JGCRP Meeting

24 September 2024

ESPS Phase 2 (Revised Modification)

Example of Declarations and Dispatches

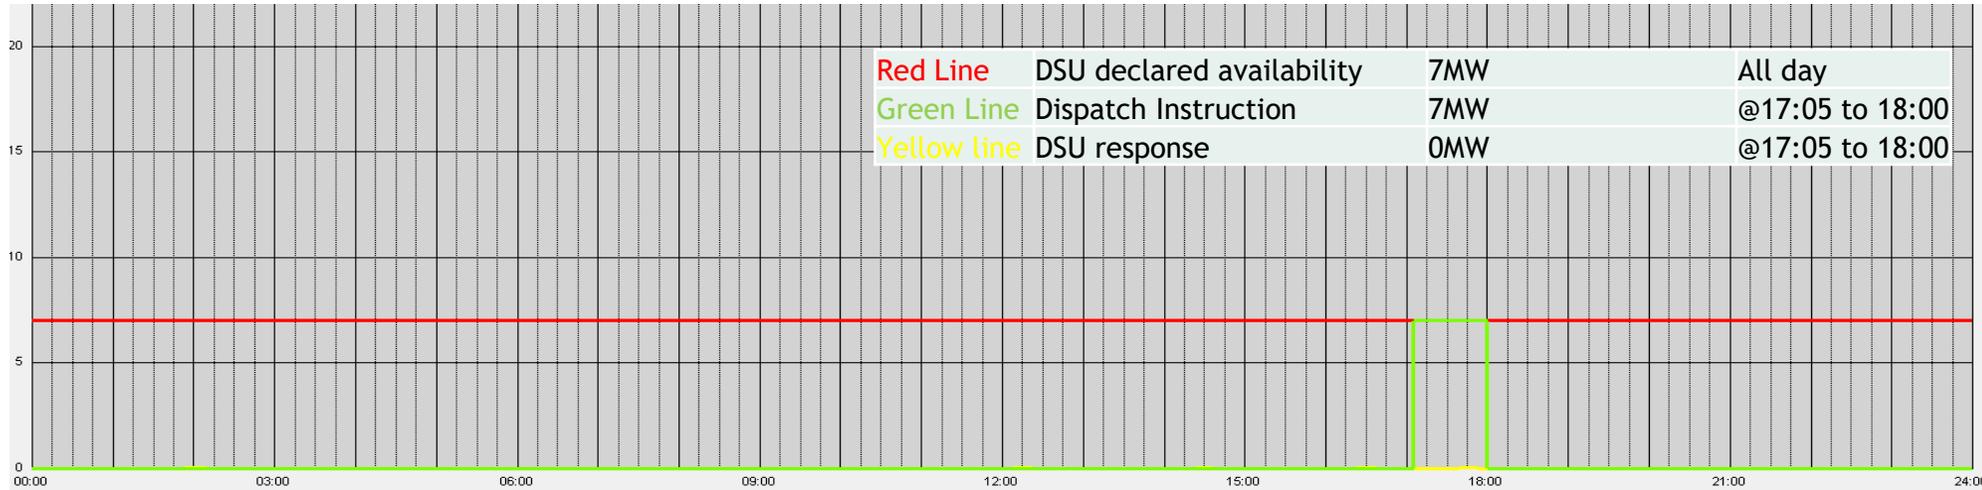
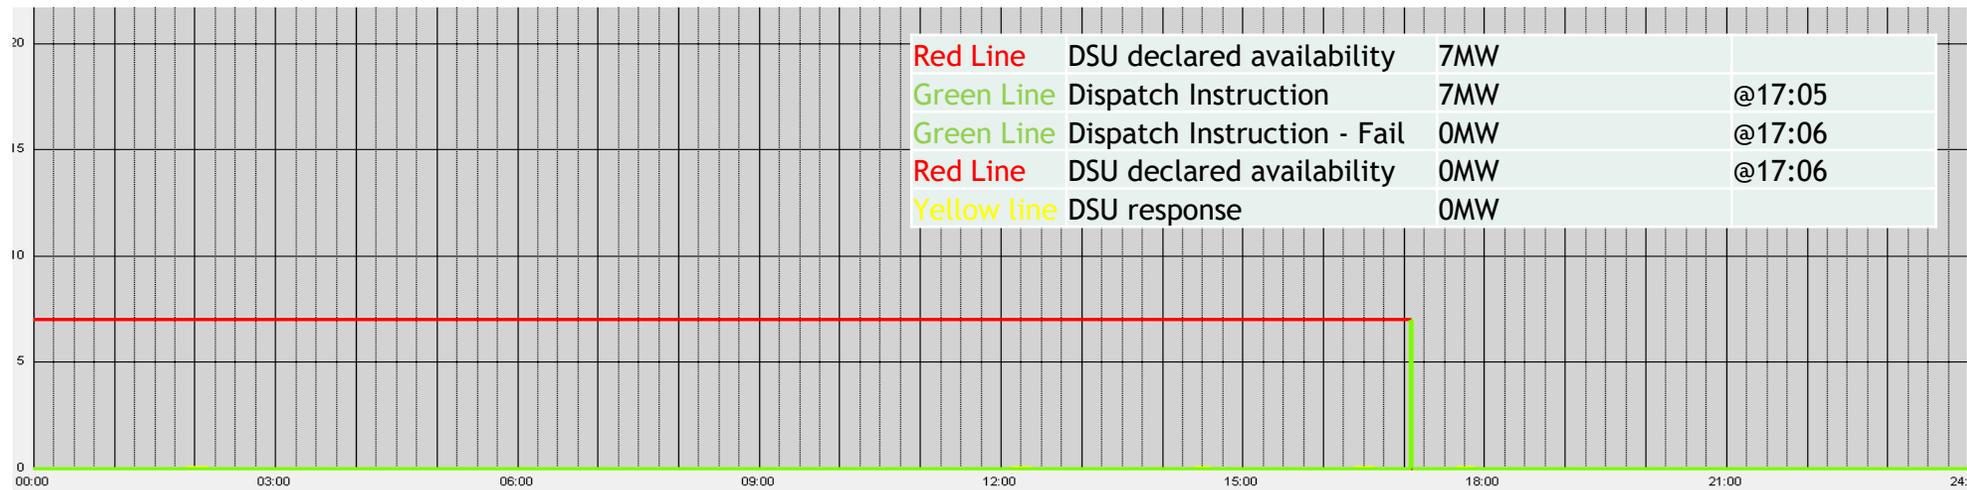
Potential unintended consequence if modification is not implemented (can occur in some cases)

Assurance with modification implemented

Working Draft of the TSOs' Proposal

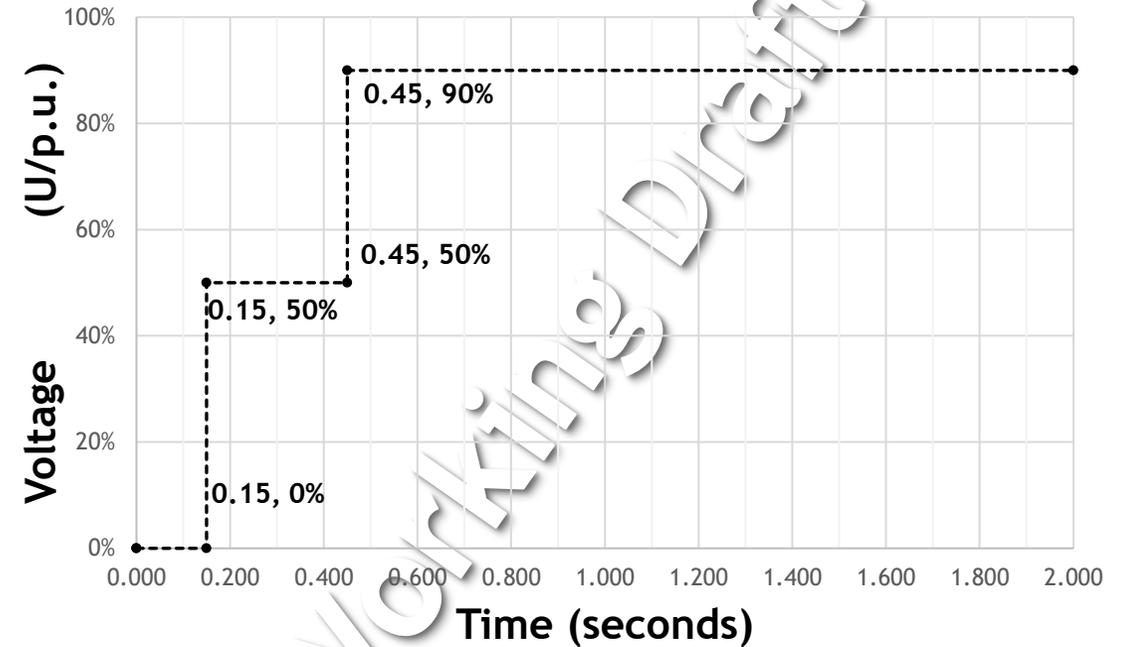
Demand Facilities shall remain connected to the Transmission System and continue to operate stably during and following any Fault Disturbance on the Power System which results in a Voltage deviation which remains on or above the voltage-against-time profile specified in the figure at the Connection Point.

Following clearance of the Fault Disturbance, the Demand Facility should return to pre-fault conditions and maintain its Demand above 95% of pre-fault value unless otherwise agreed with the TSO.

The voltage-against-time profile specifies the required capability as a function of voltage and Fault Ride-Through Time at the Connection Point before, during and after the Fault Disturbance.
